To: T10 Technical Committee  
From: Rob Elliott, HP (elliott@hp.com)  
Date: 4 July 2007  
Subject: 07-119r3 SAS-2 Far-end retimed loopback phy test function

1. Add standardized controls using the Protocol-Specific diagnostic page and the SMP PHY TEST function to place a phy into far-end retimed loopback mode.

**[Figure 1 — Far-end retimed loopback phy test mode](#)**

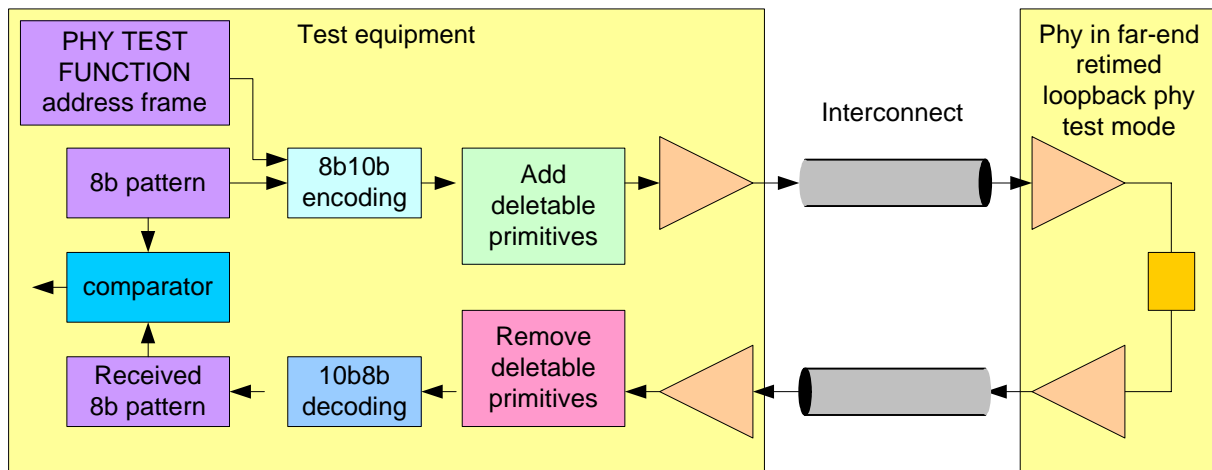
[Figure 1 shows the far-end retimed loopback phy test mode.](#)

**Figure 3 — SP (phy layer) state machine - transitions applicable to all states**

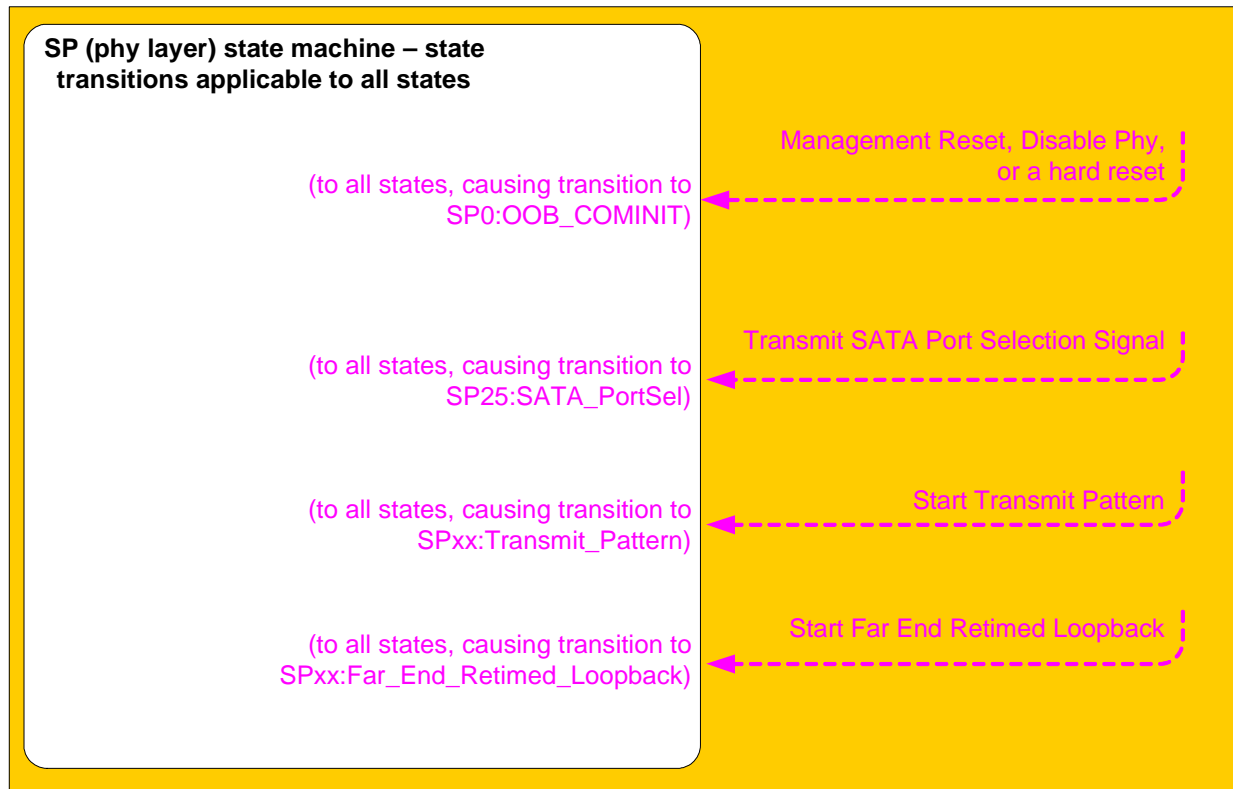
#### **6.8.3.3 Transition to SPxx:Transmit\_Pattern**

This transition shall occur after receiving a Start Transmit Pattern request (e.g., from the SMP PHY TEST FUNCTION function requesting a phy test function of TRANSMIT\_PATTERN in an expander device).

#### **6.8.3.4 Transition to SPxy:Far\_End\_Retimed\_Loopback**

This transition shall occur after receiving a Start Far End Retimed Loopback request (e.g., from the SMP PHY TEST FUNCTION function requesting a phy test function of FAR\_END\_RETIMED\_LOOPBACK in an expander device).

Figure 138 — SP (phy layer) state machine - OOB sequence states [\[modified\]](#)

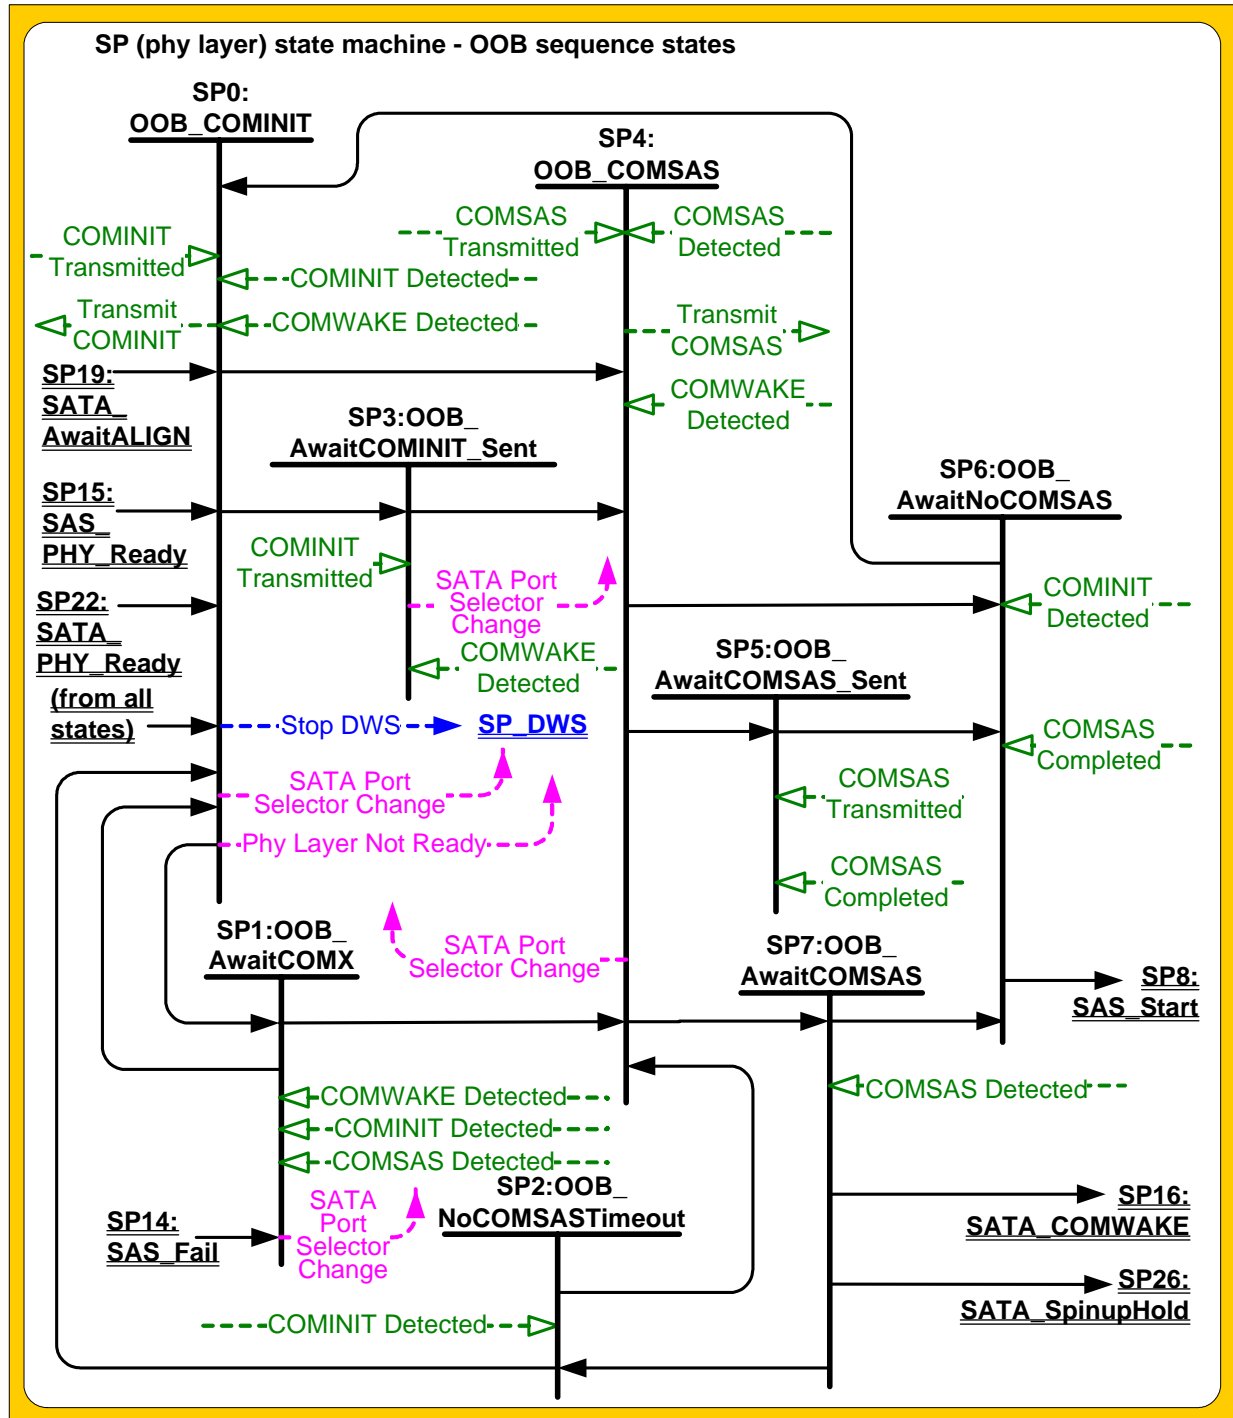
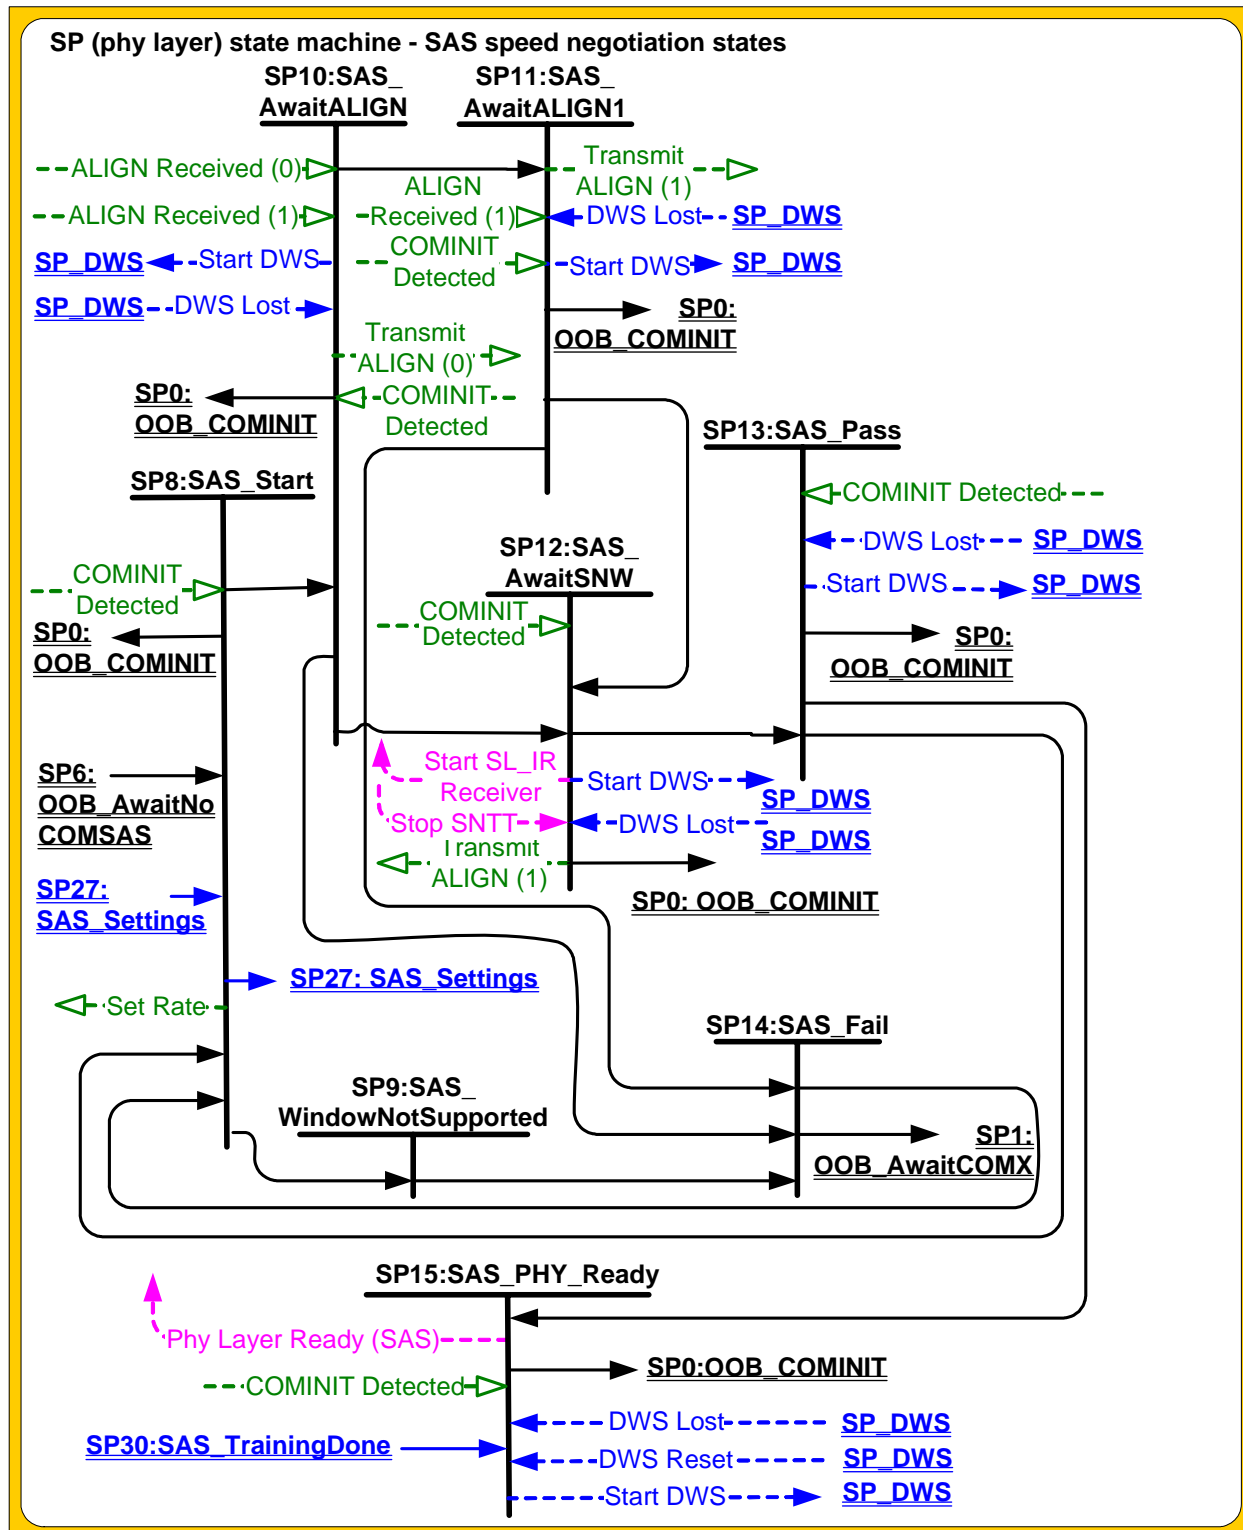
Figure 138 shows the OOB sequence states. These states are indicated by state names with a prefix of OOB.
